## **SERVICE BULLETIN**

#0017 Revision 1

**SUBJECT:** Potential risk of shearing of control stop plate rivets

**MODELS AFFECTED:** Sling 4 and Sling 4 TSi aircraft manufactured before the effective date (01/07/2020)

Figure 1 - Elevator control torque tube for Sling 4 and Sling 4 TSi aircraft

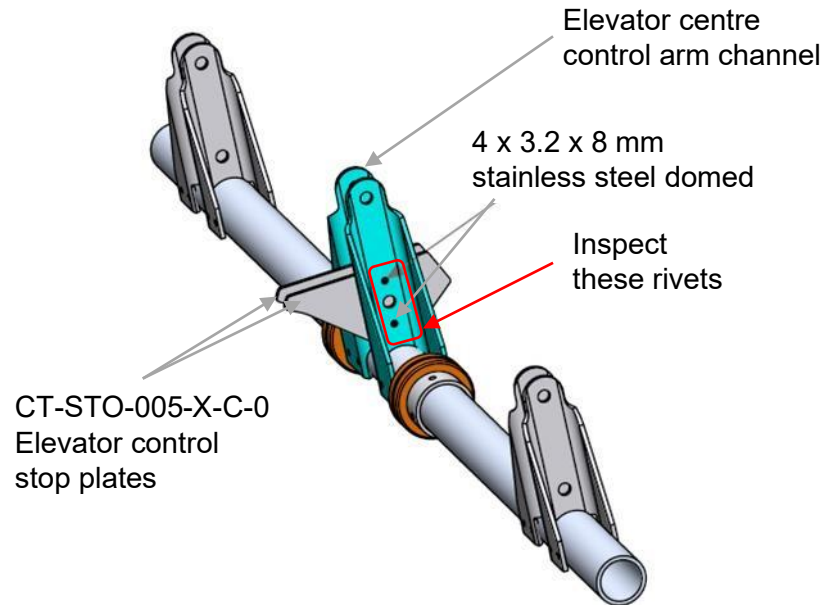
1. The rivets on the torque tube that need to be inspected are shown in Figure 1. The control stop plates (CT-STO-005-X-C-0) and elevator centre control arm channels are also shown in Figure 1.

Figure 2 – Removal of floor skin (CF-SKN-016-R-C-0)

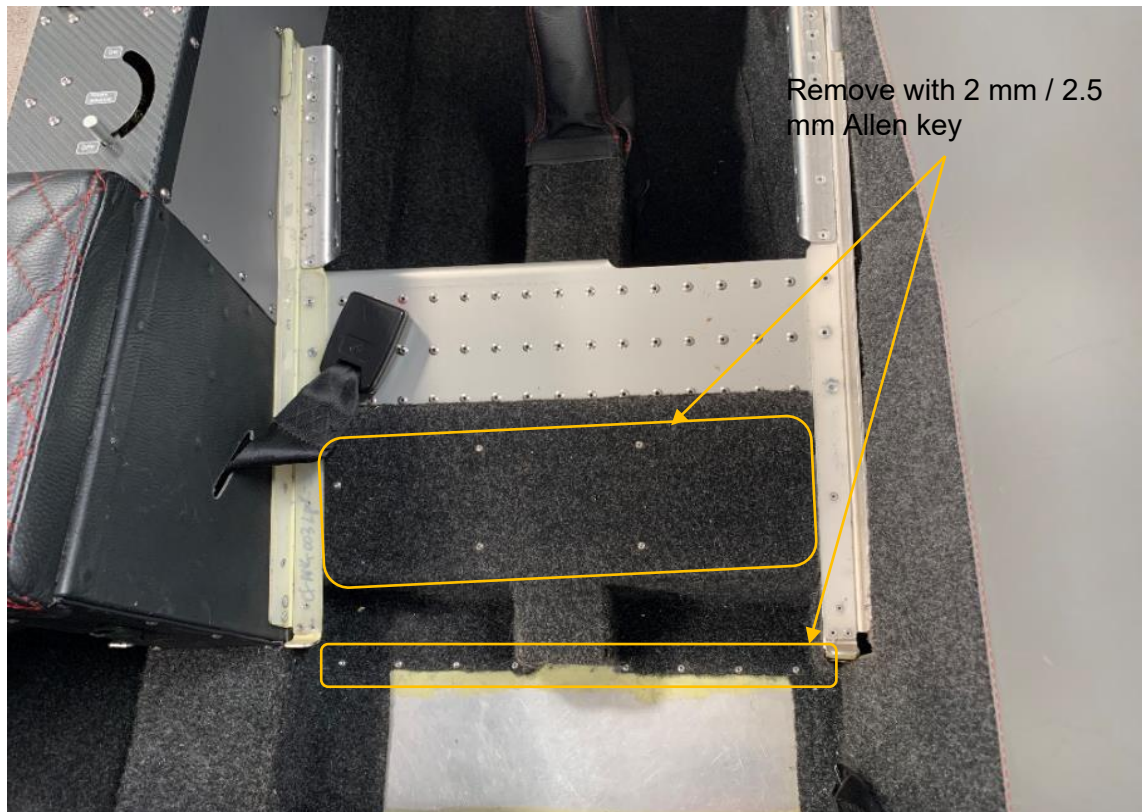
2. Remove a front seat from the fuselage then use the 2 mm / 2.5 mm Allen key to remove the floor skin (refer to CF-SKN-016-R-C-0) shown in Figure 2.
3. The inspection region when the floor skin is removed is shown in Figure 3. Use the light source to determine if control stop rivets are aluminium or stainless steel. Use Figure 4 as a guide for making the distinction.

Figure 3 - Region of inspection area and seat rail

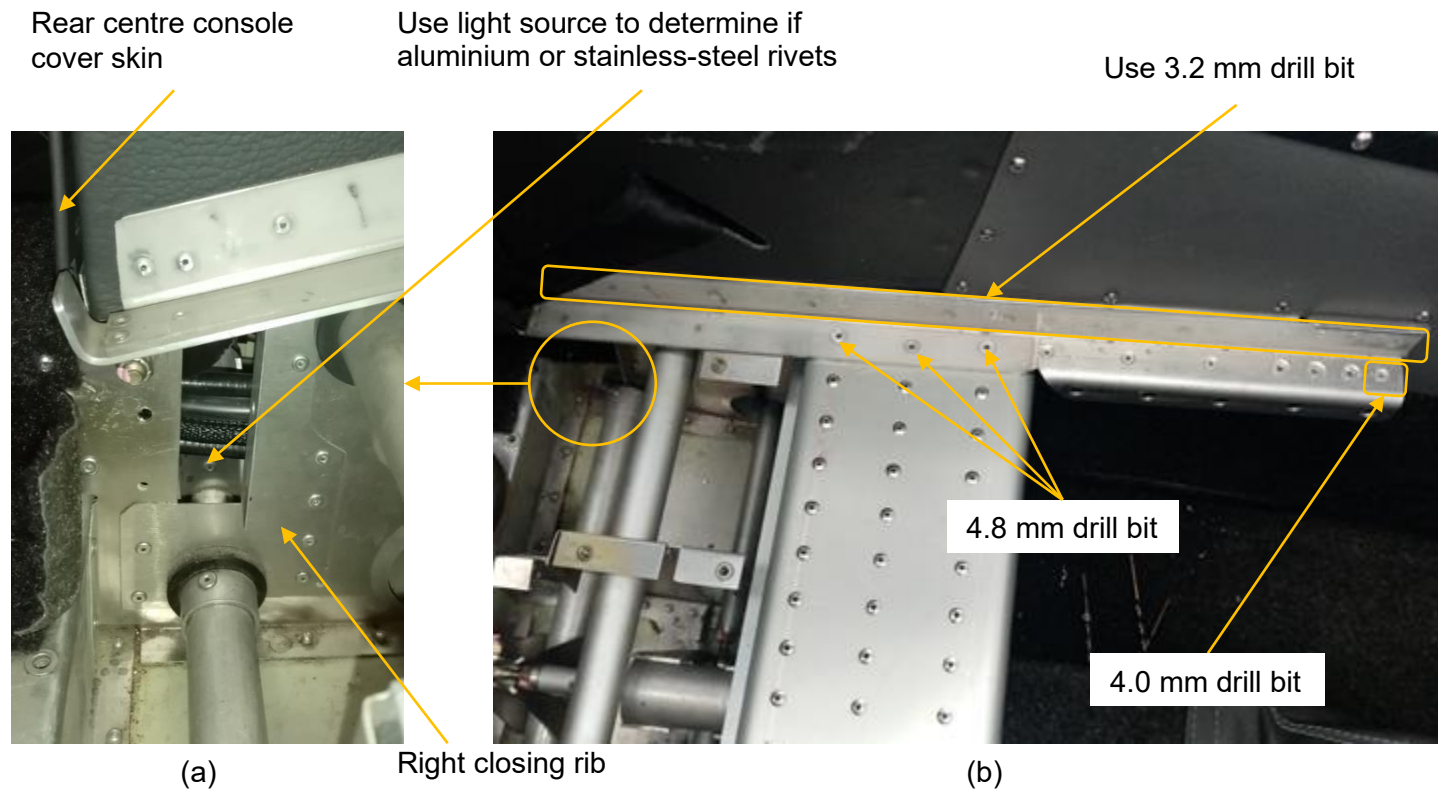
7. Drill the heads off the countersunk rivets shown in Figure 3(b) with the angle drill (using 3.2 and 4.8 mm drill bits) to remove seat rails.
8. Remove and retain all M3 / M4 screws on the aft section of the centre console to separate it from the forward section as shown in Figure 5(a).

11. Cut the cable ties that guide the centre console wiring and pitot static tubes (using the side cutter) to reduce their tautness, then use the angle drill and 3.2 mm drill bit to drill heads off the rivets on the closing rib as shown in Figure 5(b). The closing rib on the centre console RH side is shown in Figure 3(a).

17. The AN4 lock-nuts (hardware designation AN365-428A) must be tightened such that the seat belt brackets can still swivel.
18. Install the controls closing ribs (CF-RIB-009-R/L-C-0 shown in Figure 3(a)) using the 3.2 mm clecos to align the holes. Assemble with (20) 3.2 x 8 mm aluminium domed rivets.

20. Return the seat rails, including the plastic plates, using clecos to align the holes before riveting. Use the hand riveter, two 4.0 x 10 mm and six 4.8 x 15 mm countersunk aluminium rivets to assemble the seat rails. In addition, install the (18) 3.2 x 10 countersunk aluminium rivets on the upper rails (see Figure 3(b)).

21. Return the rear centre console cover skin and the floor skin shown in Figure 3(a).
22. Any dome head cap screws experiencing resistance during assembly should be cleaned with an M3 / M4 thread tap (tap size depending on year model).

Figure 4 – Identification of stainless steel and aluminium rivets

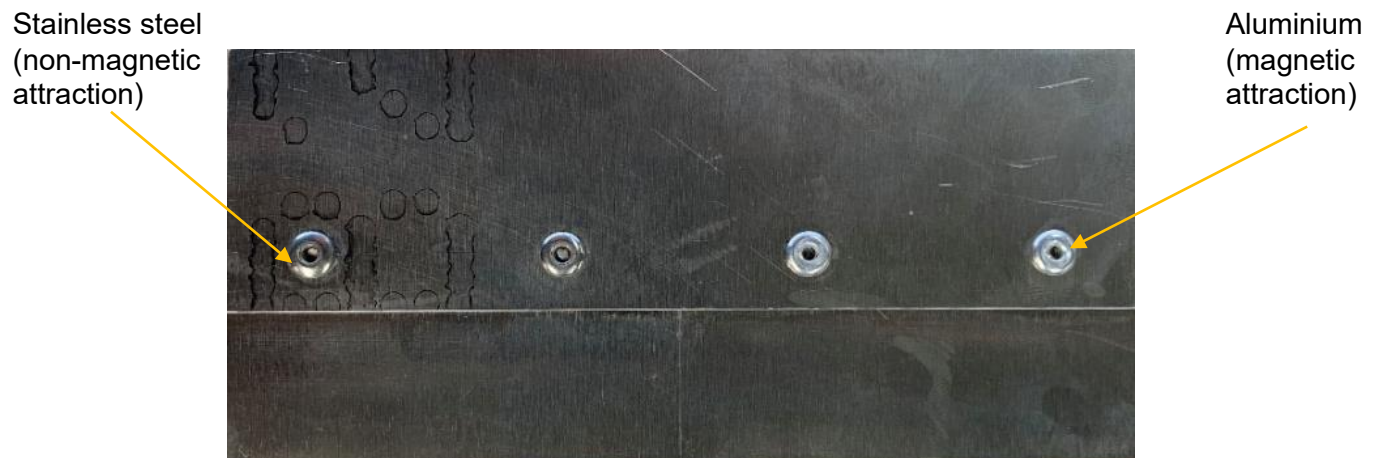
4. Alternatively (or in addition to using the light source) use a magnet to identify rivets. The mandrel of the aluminium rivet used is magnetic, so a magnet will attract to the aluminium rivet (see Figure 4).

Figure 5 – Disassembly of centre console and removal of CF-RIB-009-R/L-C-0

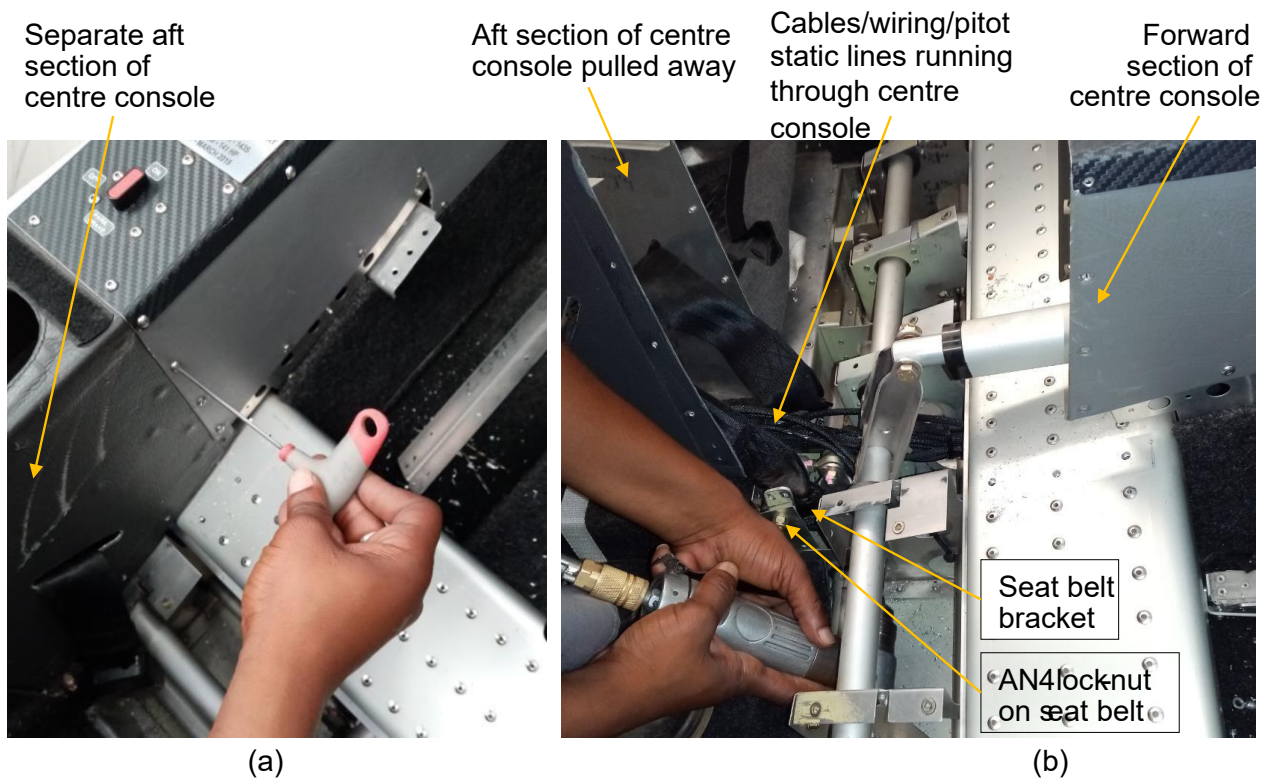
9. The aft section of the centre console must be carefully pulled away so as not to damage wiring and pitot static lines running through the console as shown in Figure 5(b). If resistance is felt separating the aft and forward centre console sections, the headset jacks should be removed with the 14 mm spanner and socket. Be sure to label these cables left and right so that they are refitted in their original positions (see Figure 6).

12. Use the 7/16" spanners to loosen the AN4 lock-nuts (hardware designation AN365-428A) on seat belt shown in Figure 5(b) so that the seat belt bracket can swivel. This will ensure there is sufficient room for the hand riveter to be pressed firmly against elevators' centre control arm channel when installing the 3.2 x 8 mm stainless steel rivets (See Figure 7).

19. Return the aft section of the centre console using the 2 mm / 2.5 mm Allen key and install the M3 / M4 screws (see Figure 5(a) which shows disassembly).
